Appendix 6 Further Information and third party responses to concerns raised regarding the Proposed Lyrenacarriga WF, Counties Cork and Waterford

Drawing No.			
	<h2>Figure 2-2a FI</h2>			
Drawing Title				
<h3>Other Wind Farms</h3>				
Project Title				
<h3>Lyrenacarriga Renewable Energy Development</h3>				
Scale	Project No.	Date	Drawn By	Checked By
1:150,000	170749e	03.10.2022	JS	MC

***HES TECHNICAL NOTE T5 &
ASSOCIATED DRAWING***

TURBINE T5 ALTERNATIVE LOCATION

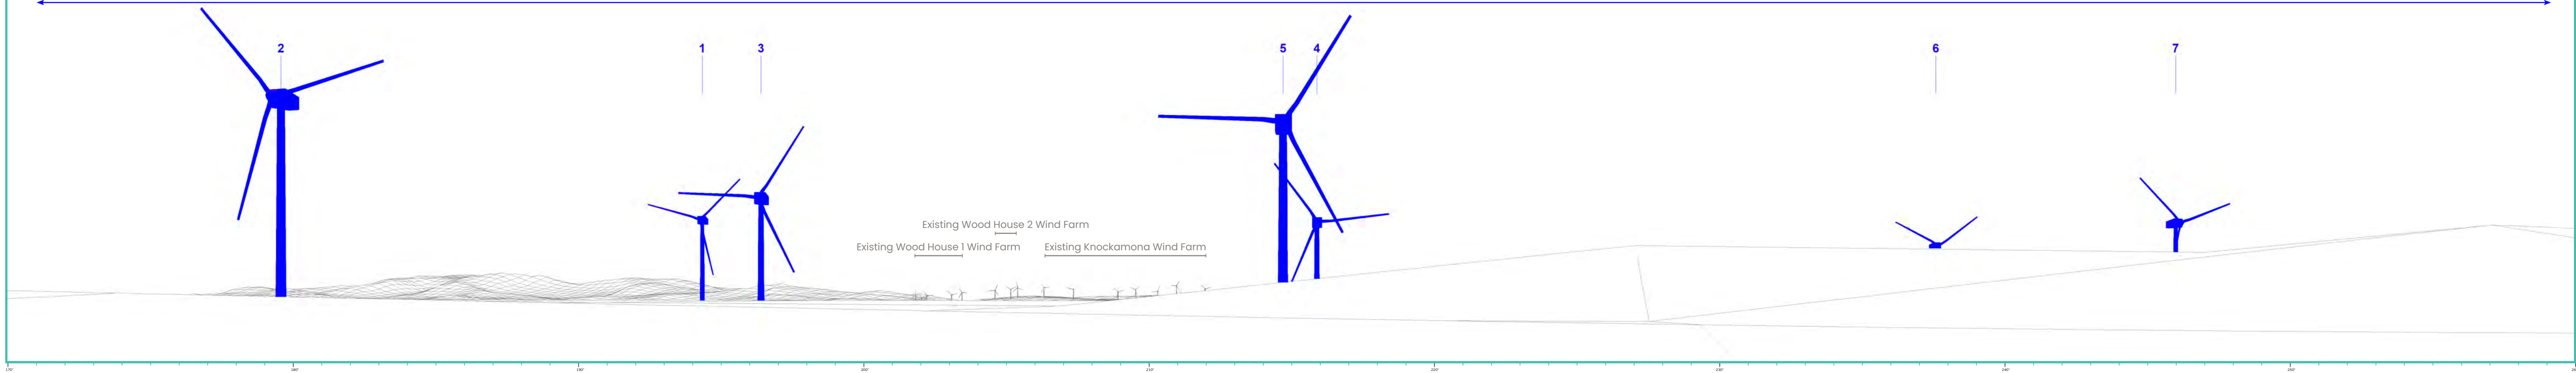
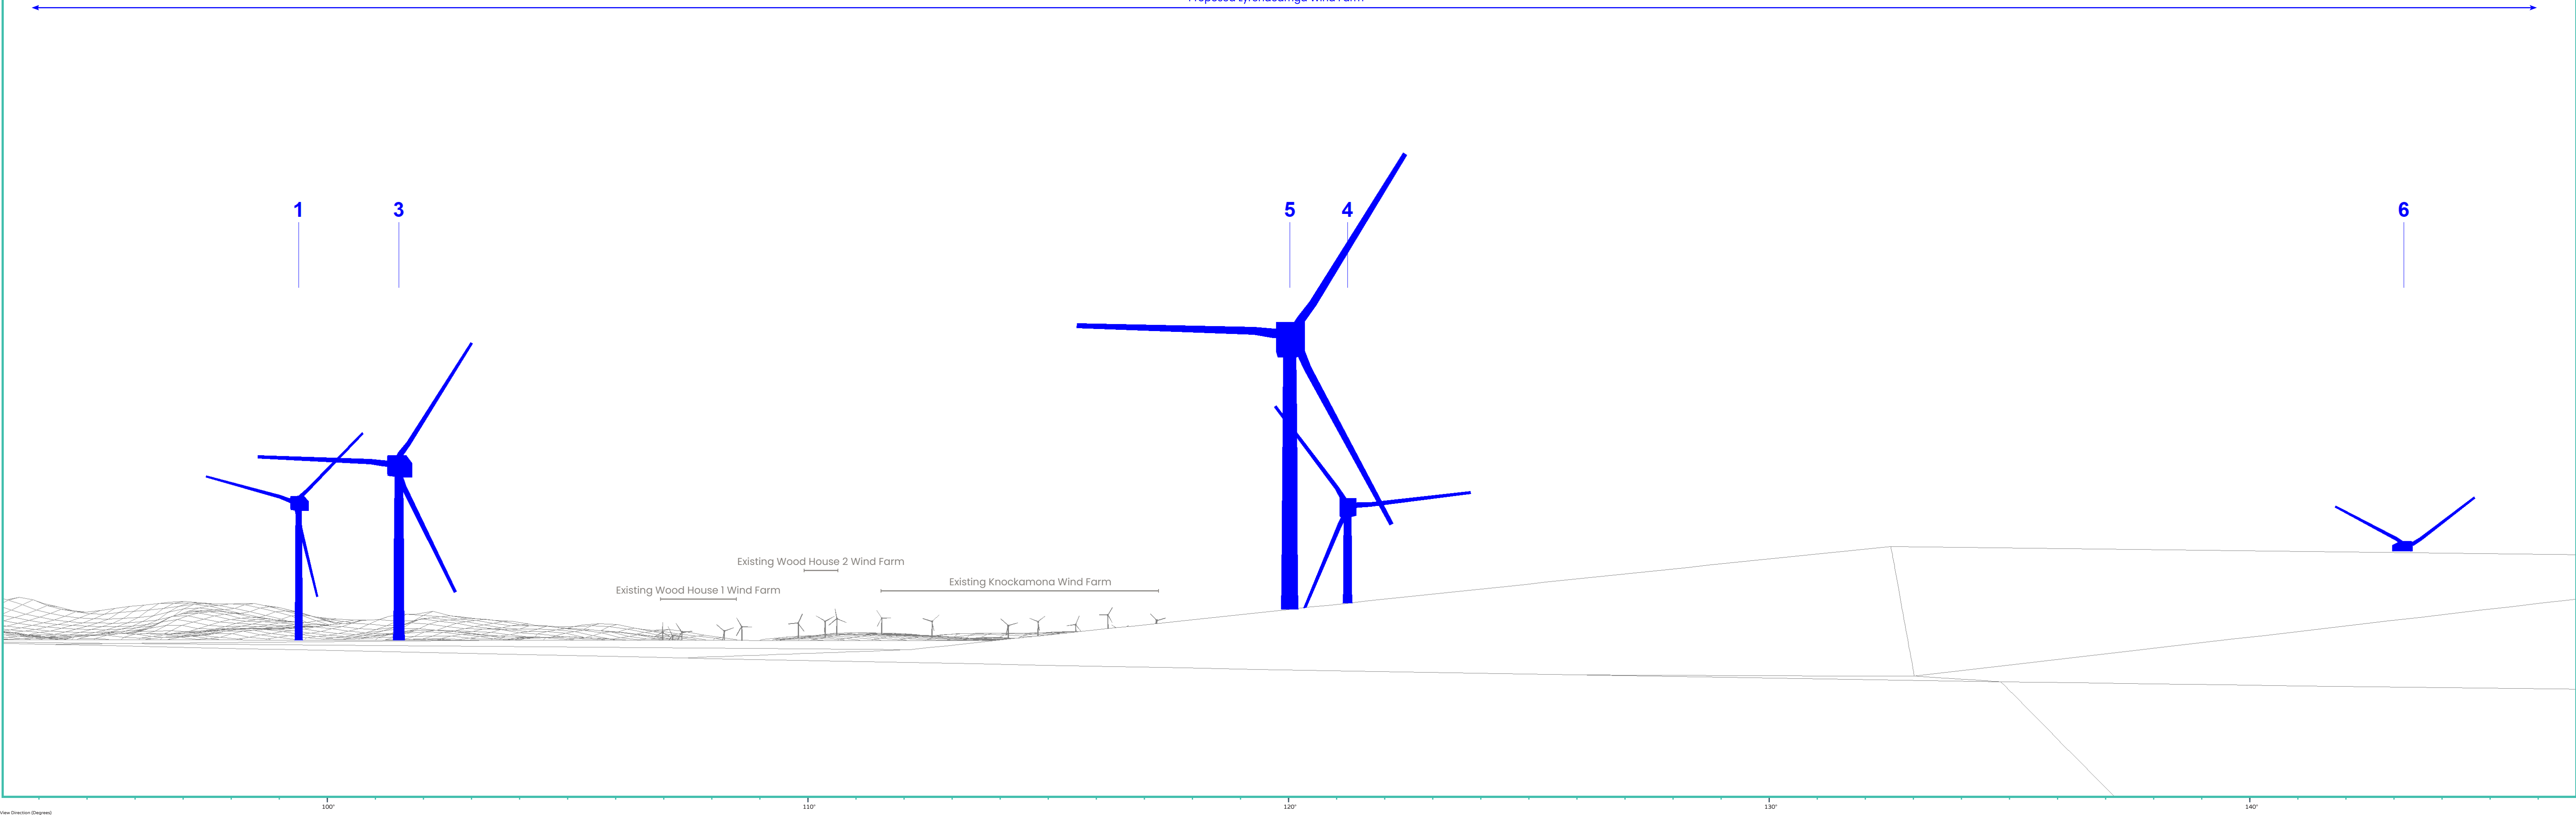
Proposed Photomontage with Cumulative at 90° (with alternative T5 location)

Proposed Photomontage with Cumulative at 53.5° (with alternative T5 location)

Figure A: Hydrological Constraints Mapping at T5 Location

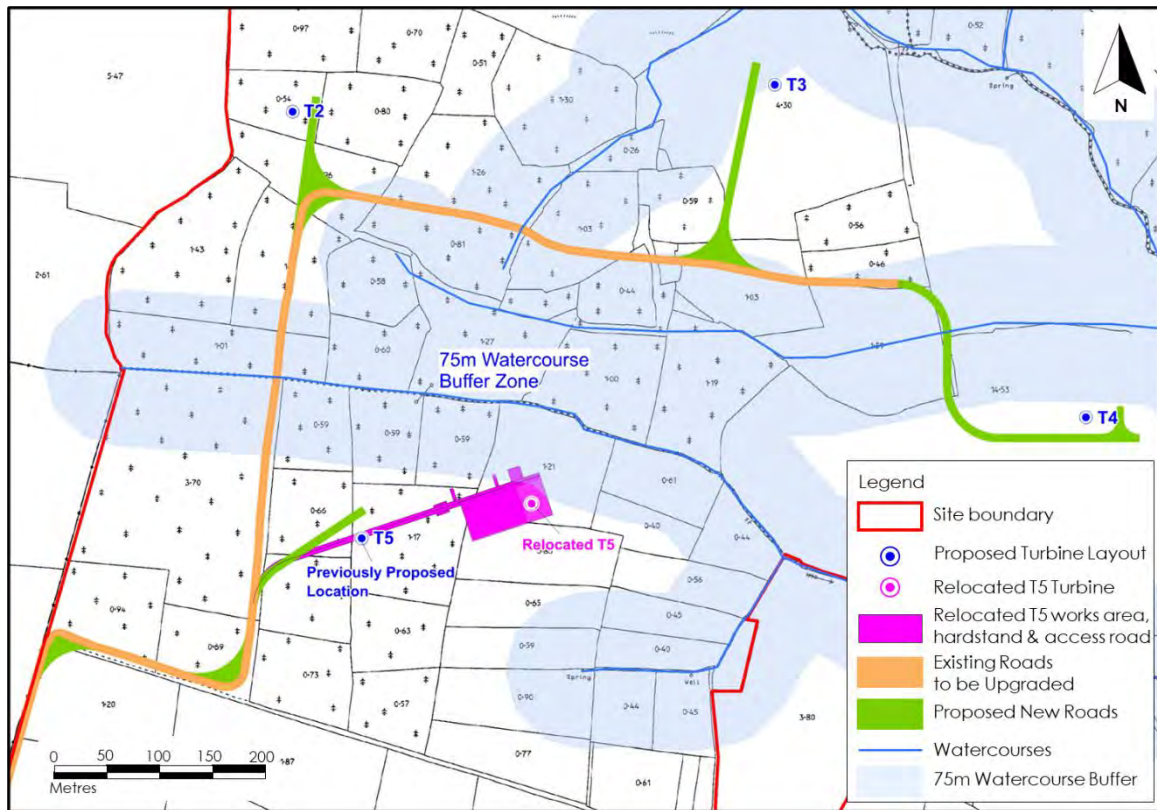
The proposed new T5 location will require 189m of additional access road. The turbine hardstand area/footprint will not change.

The previously mapped hydrological constraints in the area of the previously proposed and new T5 location are shown in **Figure A** below. The turbine foundation/base is located outside the 75m watercourse buffer zone.

Albeit there will be a slight increase in access road length, the proposed new T5 location will not result in any change of potential effects to those assessed in the 2021 EIAR with regard Land, Soils/Geology and Water environments.

Appendix I
Revised Drainage Plan

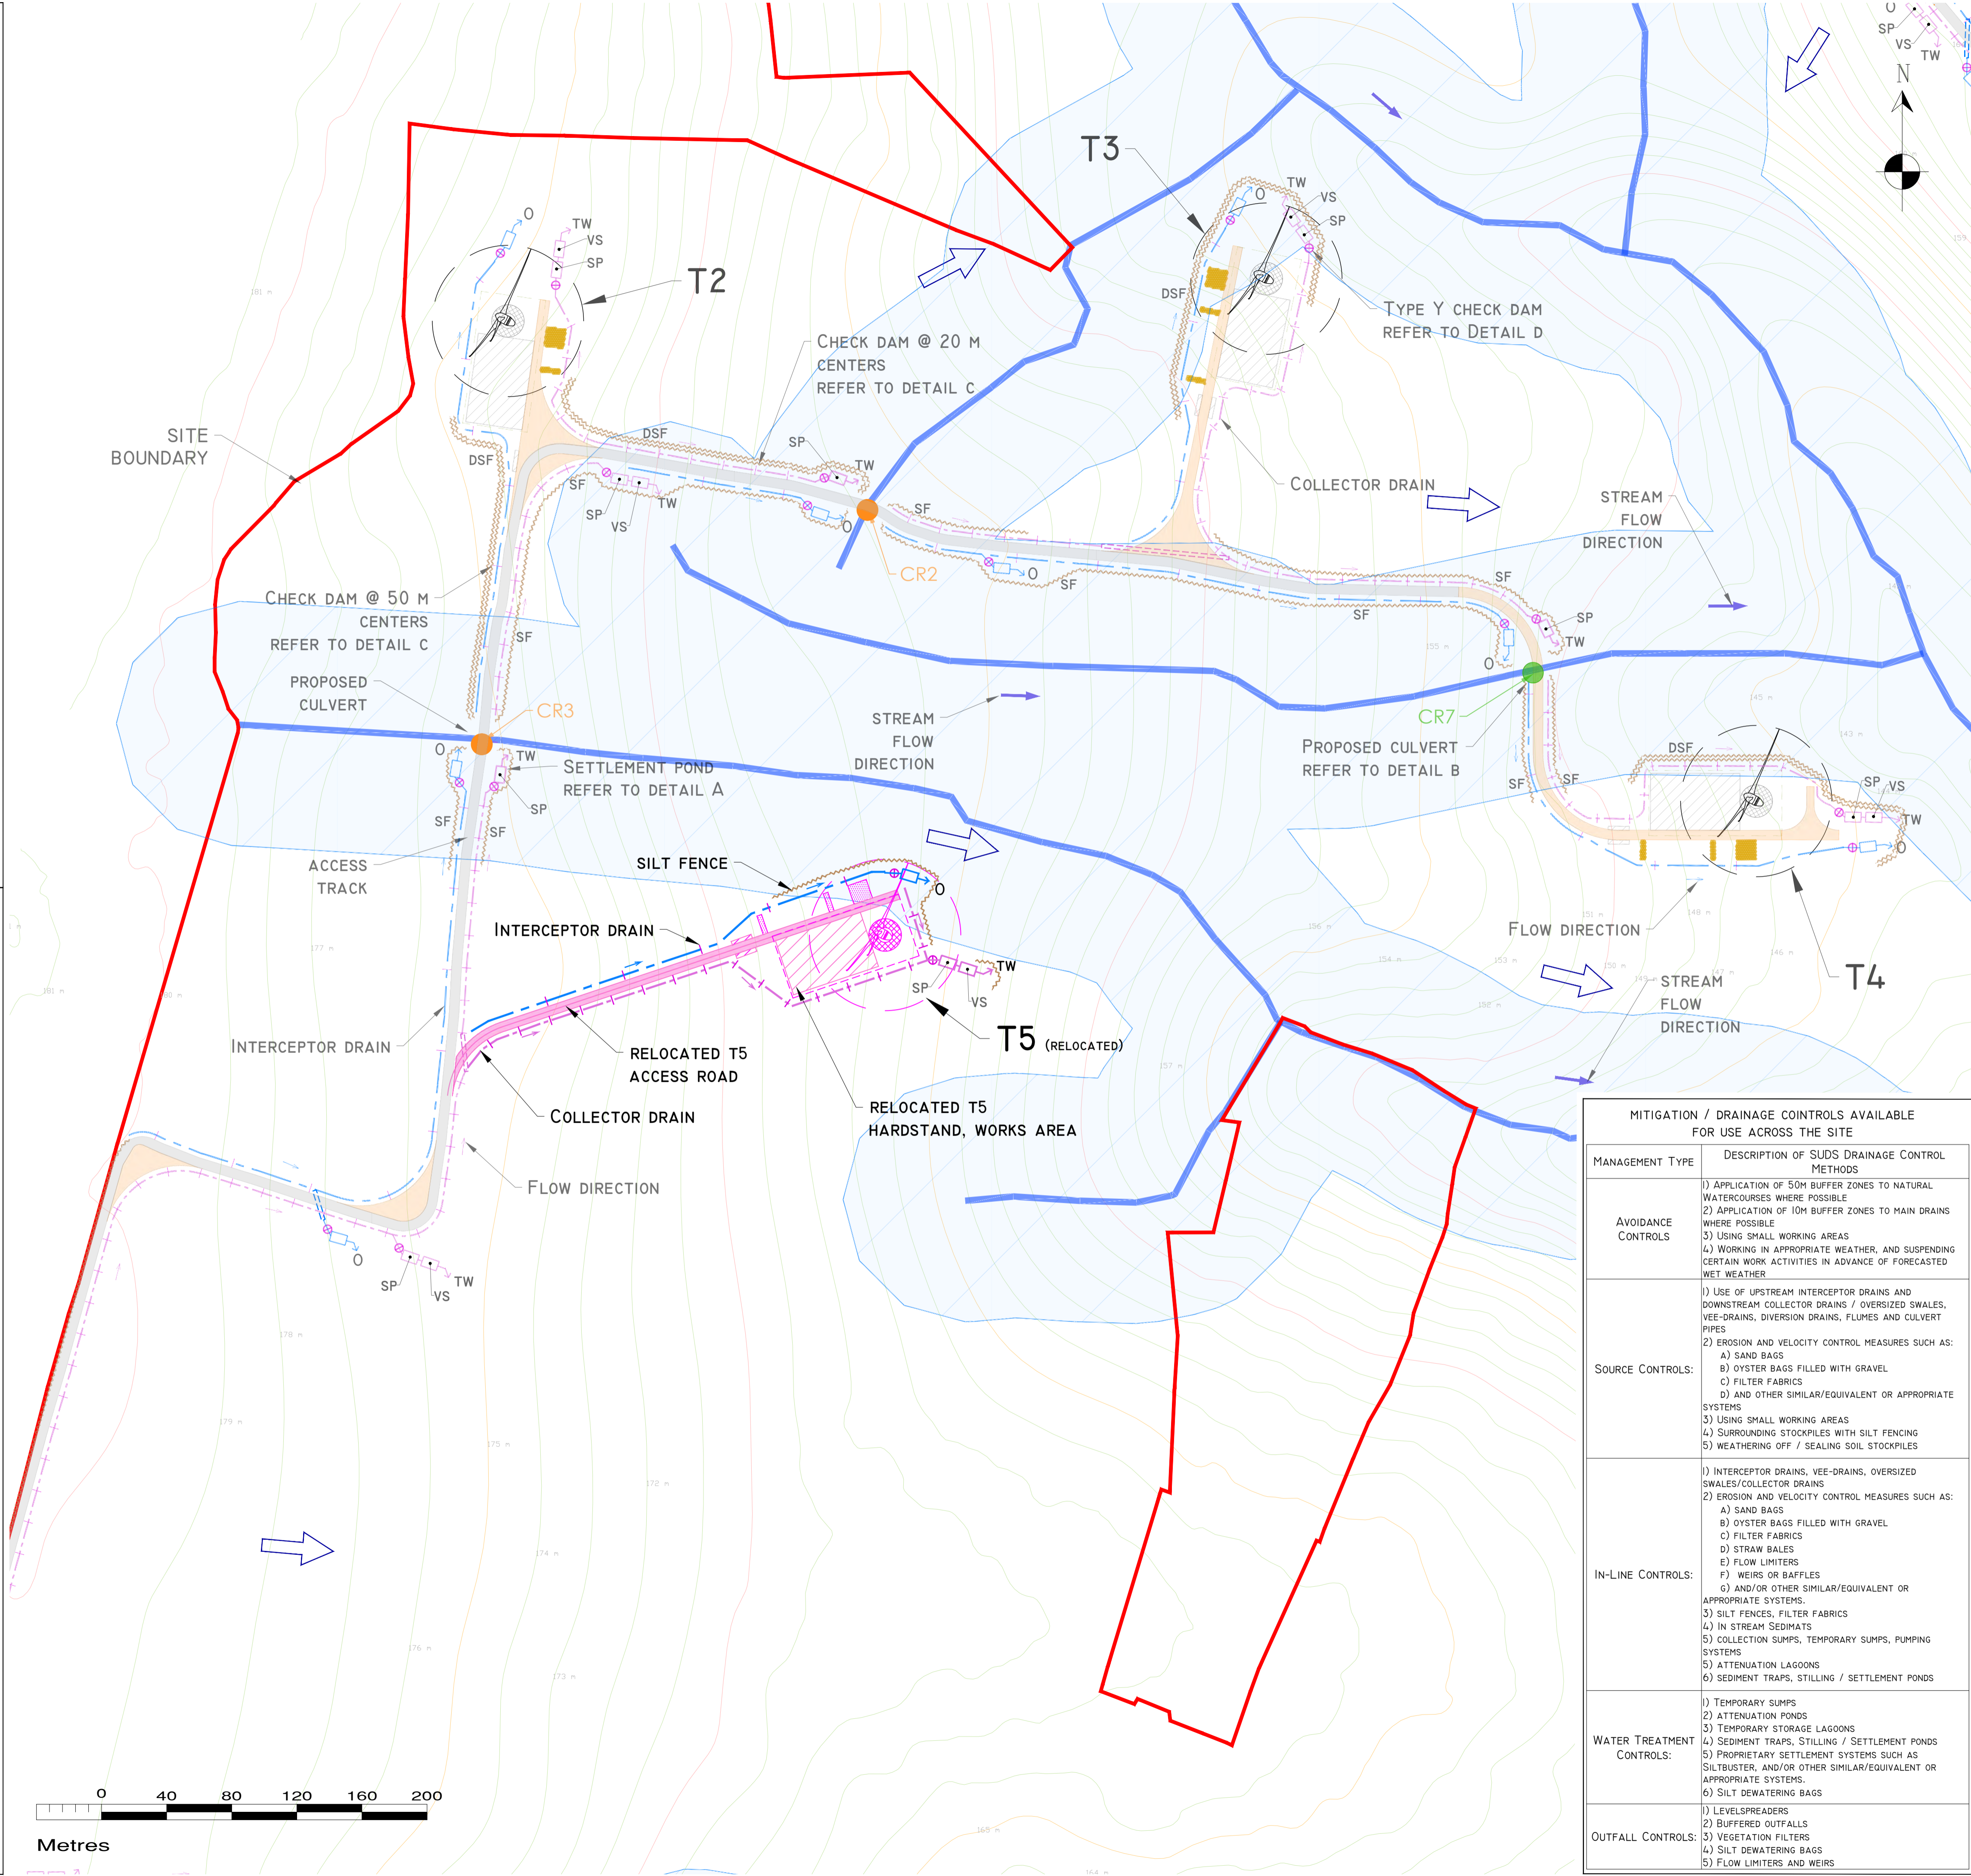
The wind farm drainage plan, which has been revised for the proposed T5 relocation, is attached as **Appendix I** below.
